Model Name: KAT00 DIS

PCB NO: LA-5151P

## Schematic Document

### POITIER Montevina M96/M92

## Free Fall Sensor

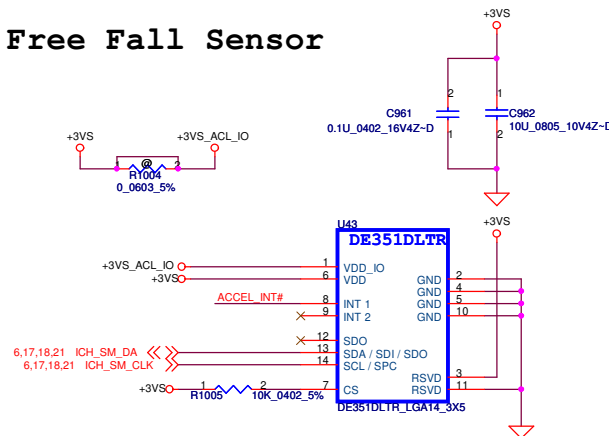
| Item | Page# | Title                   | Date       | Request Owner | Issue Description                                                                                                                                                                  | Solution Description                                                                                                                                                                                                                                                                                                                                                                                                                                                                                                                                                                                      | Rev.        |
|------|-------|-------------------------|------------|---------------|------------------------------------------------------------------------------------------------------------------------------------------------------------------------------------|-----------------------------------------------------------------------------------------------------------------------------------------------------------------------------------------------------------------------------------------------------------------------------------------------------------------------------------------------------------------------------------------------------------------------------------------------------------------------------------------------------------------------------------------------------------------------------------------------------------|-------------|
| 15   | 20    | FFS                     | 2009/02/26 | Compal        | Add FFS function                                                                                                                                                                   | Add FFS parts in page 20                                                                                                                                                                                                                                                                                                                                                                                                                                                                                                                                                                                  | Rev02 (X01) |

| Item | Page# | Title          | Date       | Request Owner | Issue Description                                                                                                                                                                                                              | Solution Description                                                                                                                                                                                                      | Rev.        |
|------|-------|----------------|------------|---------------|--------------------------------------------------------------------------------------------------------------------------------------------------------------------------------------------------------------------------------|---------------------------------------------------------------------------------------------------------------------------------------------------------------------------------------------------------------------------|-------------|
| 12   | 20    | FFS            | 2009/05/04 | Compal        | original PIRQH is by USB controller used                                                                                                                                                                                       | FFS change int to PIRQ setting from PIRQH to PIRQE                                                                                                                                                                        | Rev03 (X02) |

### *Express Card*

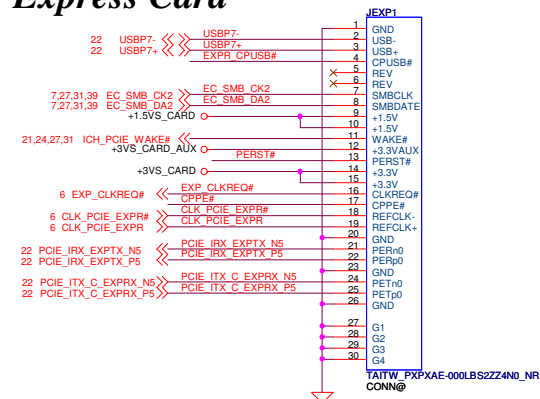
| Item | Page# | Title          | Date       | Request Owner | Issue Description                                                                                                                                                                                                              | Solution Description                                                                                                                                                                                                      | Rev.        |
|------|-------|----------------|------------|---------------|--------------------------------------------------------------------------------------------------------------------------------------------------------------------------------------------------------------------------------|---------------------------------------------------------------------------------------------------------------------------------------------------------------------------------------------------------------------------|-------------|
| 3    | 28    | Express card   | 2009/04/27 | Compal        | Express card socket type error, change to normail type, not reverse type.                                                                                                                                                      | JEXP1 change to TAITW_PXPXAE-000LS2ZZ4N0_NR part.                                                                                                                                                                         | Rev03 (X02) |

### SATA HDD (On board)

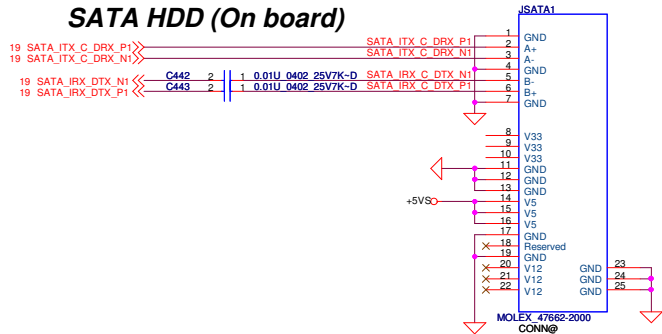
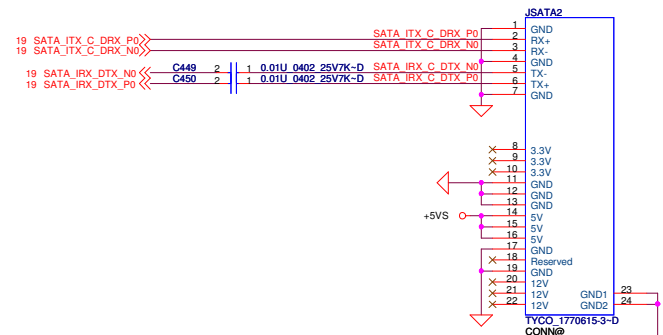
| Item | Page# | Title          | Date       | Request Owner | Issue Description                                                                                                                                                                                                              | Solution Description                                                                                                                                                                                                      | Rev.        |
|------|-------|----------------|------------|---------------|--------------------------------------------------------------------------------------------------------------------------------------------------------------------------------------------------------------------------------|---------------------------------------------------------------------------------------------------------------------------------------------------------------------------------------------------------------------------|-------------|
| 29   |       | SATA HDD       |            | Compal        | SATA port 0 & Port 1 change.                                                                                                                                                                                                   | Chagne SATA port 0 connect from JSATA1 to JSATA2.<br>Chagne SATA port 1 connect from JSATA2 to JSATA1.                                                                                                                    | Rev02 (X01) |

### +5VALW to +5VS Transfer

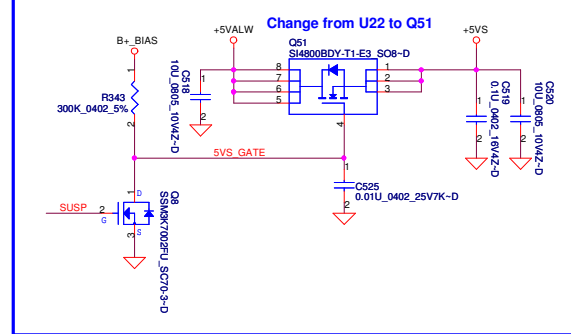
| Item | Page# | Title          | Date       | Request Owner | Issue Description                                                                                                                                                                                                              | Solution Description                                                                                                                                                                                                      | Rev.        |
|------|-------|----------------|------------|---------------|--------------------------------------------------------------------------------------------------------------------------------------------------------------------------------------------------------------------------------|---------------------------------------------------------------------------------------------------------------------------------------------------------------------------------------------------------------------------|-------------|
| 8    | 33    | DC / DC        | 2009/04/30 | Compal        | Modify +5VALW to +5VS transfer circuit.                                                                                                                                                                                        | 1. Change R338 to 300K ohm, Change Q50 to SI4392DY.<br>2. Add R340 2M_0402 connect to GND.                                                                                                                                | Rev03 (X02) |

### Discharge Circuit

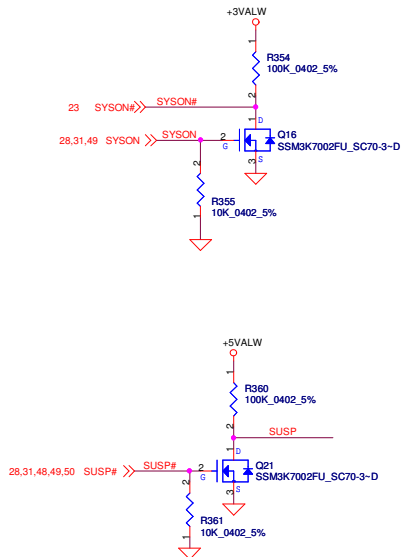
| Item          | Page#         | Title                  | Date                  | Request Owner     | Issue Description                                                                                                                                                                                                                                                                                                                                                                                                                                                            | Solution Description                                                                                                                                                                                                                                                                           | Rev.                   |
|---------------|---------------|------------------------|-----------------------|-------------------|------------------------------------------------------------------------------------------------------------------------------------------------------------------------------------------------------------------------------------------------------------------------------------------------------------------------------------------------------------------------------------------------------------------------------------------------------------------------------|------------------------------------------------------------------------------------------------------------------------------------------------------------------------------------------------------------------------------------------------------------------------------------------------|------------------------|
| 19            | 33            | Discharge circuit      | 2009/05/04            | Compal            | double discharge for +3VS (+3V_WLAN)                                                                                                                                                                                                                                                                                                                                                                                                                                         | Delete R357, Q18 +3V_WLAN discharge circuit.                                                                                                                                                                                                                                                   | Rev03 (X02)            |

+1.05V\_VCCP  
 Thermal Desig Current=7.88A  
 Peak Current=9.85A  
 OCP min=11.82A  
 Fsw=300KHz  
 $V_o=1.05V$   $V_{FB}=0.75V$   
 $V_o=V_{FB} \cdot (1+PR430/PR433)=0.75 \cdot (1+8.66K/21.5K)=1.052V$

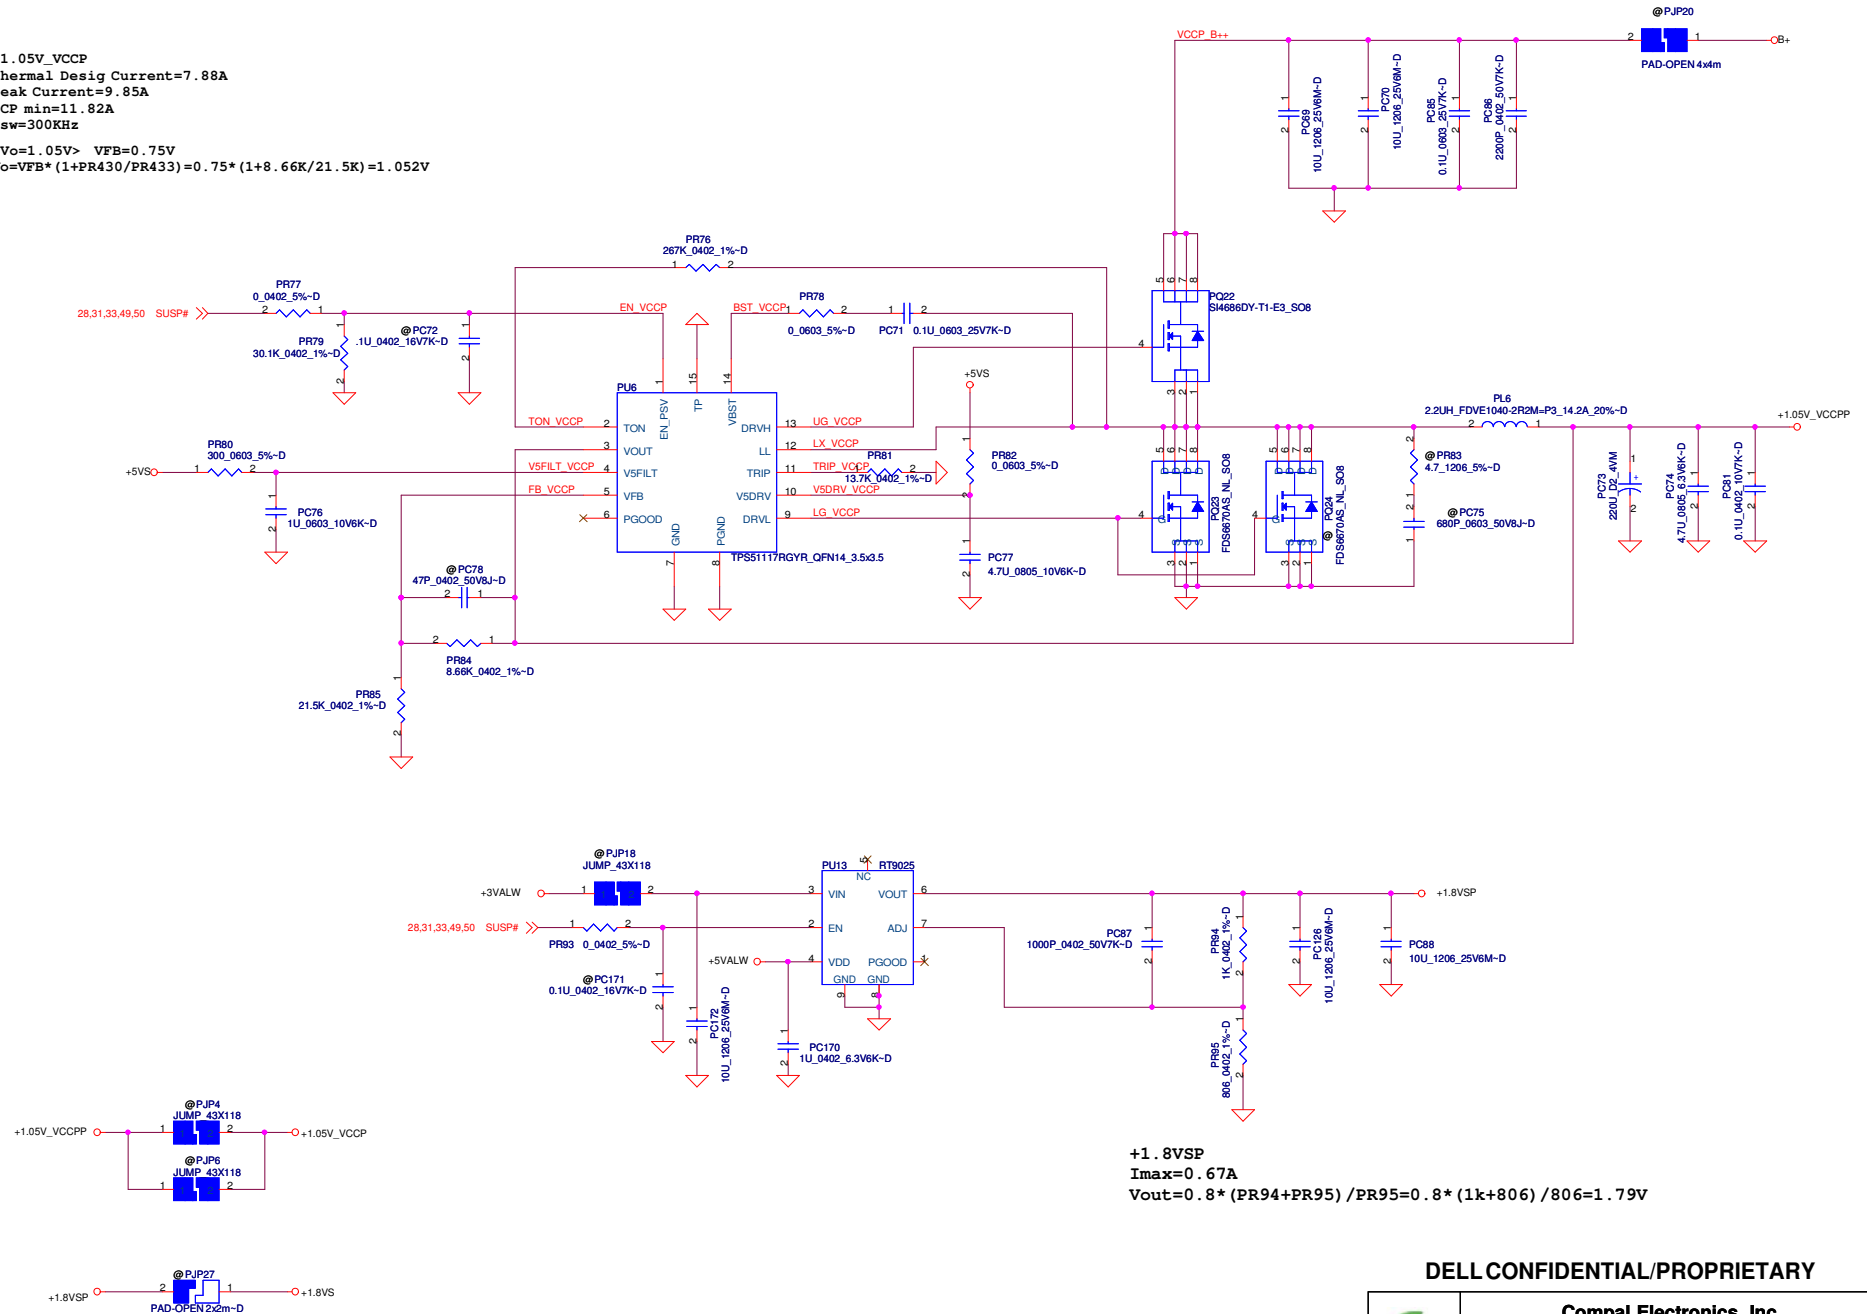
| Item | Page# | Title                          | Date  | Request Owner | Issue Description                                                        | Solution Description                                                                                                                      | Rev. |
|------|-------|--------------------------------|-------|---------------|--------------------------------------------------------------------------|-------------------------------------------------------------------------------------------------------------------------------------------|------|
| 03   | 48    | +1.05V_VCCP/<br>+1.8VSP        | 01/22 | Compal Mike   | Setiing +1.05V_VCCP OCP to 11.82A                                        | Change PR81 from P/N: SD03480618L (8.06K +-1% 0402) to SD03416228L (16.2K +-1% 0402)                                                      | X01  |

| Item | Page# | Title                   | Date  | Request Owner | Issue Description                                   | Solution Description                                                                         | Rev. |
|------|-------|-------------------------|-------|---------------|-----------------------------------------------------|----------------------------------------------------------------------------------------------|------|
| 21   | 48    | +1.05V_VCCP/<br>+1.8VSP | 03/04 | Compal Antony | Change Rtrip resistance to meet OCP setting         | Change PR81 from 16.2K ohm to 13.7K ohm                                                      | X01  |

| Item | Page# | Title                 | Date  | Request Owner | Issue Description                                         | Solution Description                                      | Rev. |
|------|-------|-----------------------|-------|---------------|-----------------------------------------------------------|-----------------------------------------------------------|------|
| 40   | 48    | 1.05V_VCCP/<br>1.8VSP | 03/20 | Compal Antony | For phase margin improved                                 | Add PC87 1000pF between PU13 pin6 and PU13 pin7           | X01  |
| 41   | 48    | 1.05V_VCCP/<br>1.8VSP | 03/20 | Compal Antony | For phase margin improved                                 | Add PC126 10uF between PU13 pin6 and PU13 GND             | X01  |

1.5V  
Thermal Design Current=13.52A  
Peak Current=16.91A  
OCP min=20A  
Fsw=298KHz

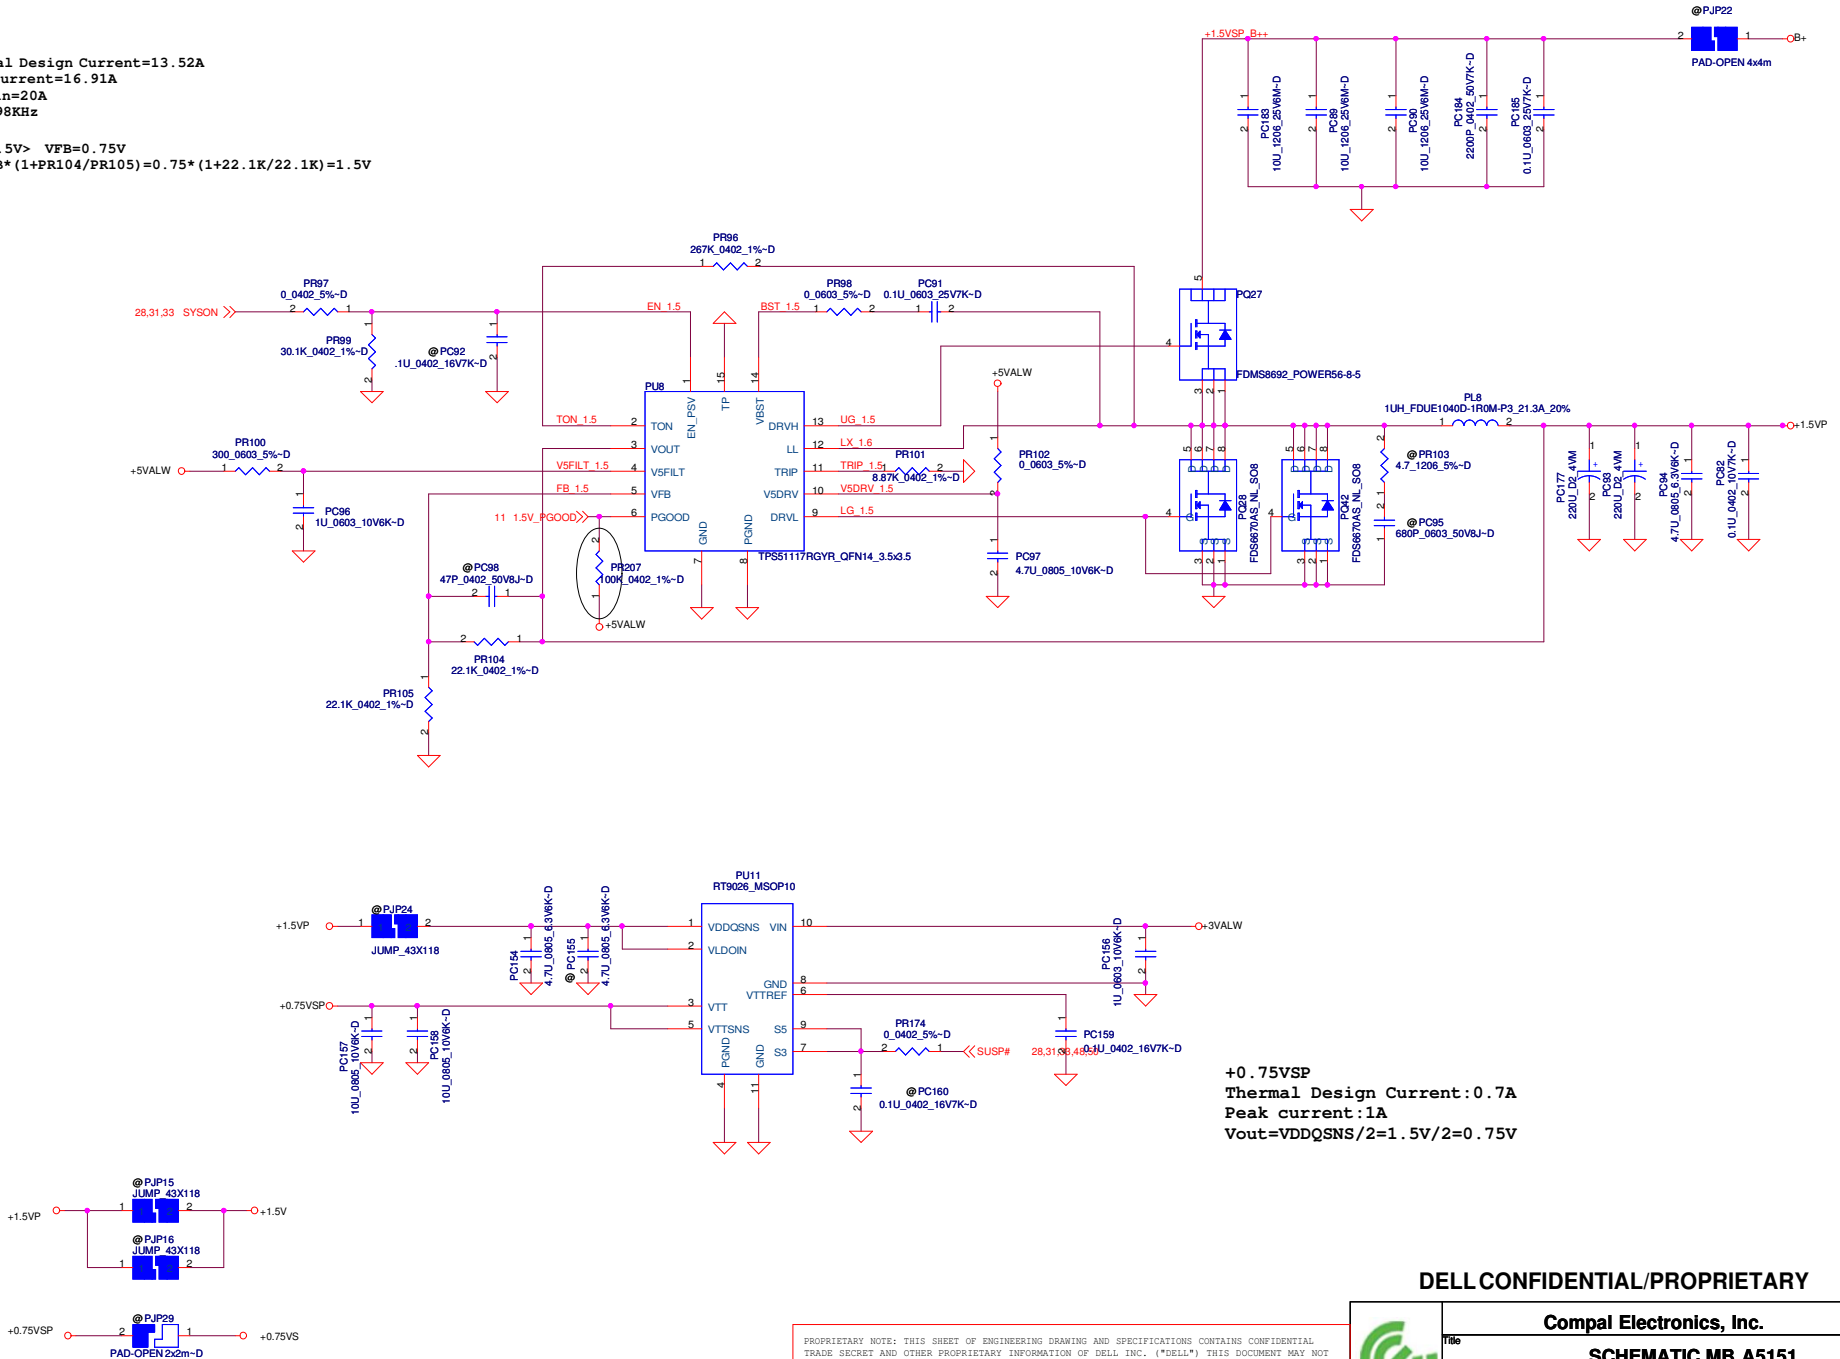
| Item | Page# | Title                          | Date  | Request Owner | Issue Description                                                        | Solution Description                                                                                                                      | Rev. |
|------|-------|--------------------------------|-------|---------------|--------------------------------------------------------------------------|-------------------------------------------------------------------------------------------------------------------------------------------|------|
| 05   | 49    | +1.5VSP/0.75VSP                | 01/22 | Compal Mike   | HW need to use +1.5VSP PGOOD signal,so need to add a pull high resister. | Add PR207 SD03410038L (100K +-1% 0402) between PU8 pin6 and PR97 pin 2.                                                                   | X01  |

| Item | Page# | Title                   | Date  | Request Owner | Issue Description                                   | Solution Description                                                                         | Rev. |
|------|-------|-------------------------|-------|---------------|-----------------------------------------------------|----------------------------------------------------------------------------------------------|------|
| 22   | 49    | +1.5VSP/0.75VSP         | 03/04 | Compal Antony | Change Rtrip resistance to meet OCP setting         | Change PR101 from 13.7K ohm to 8.87K ohm                                                     | X01  |
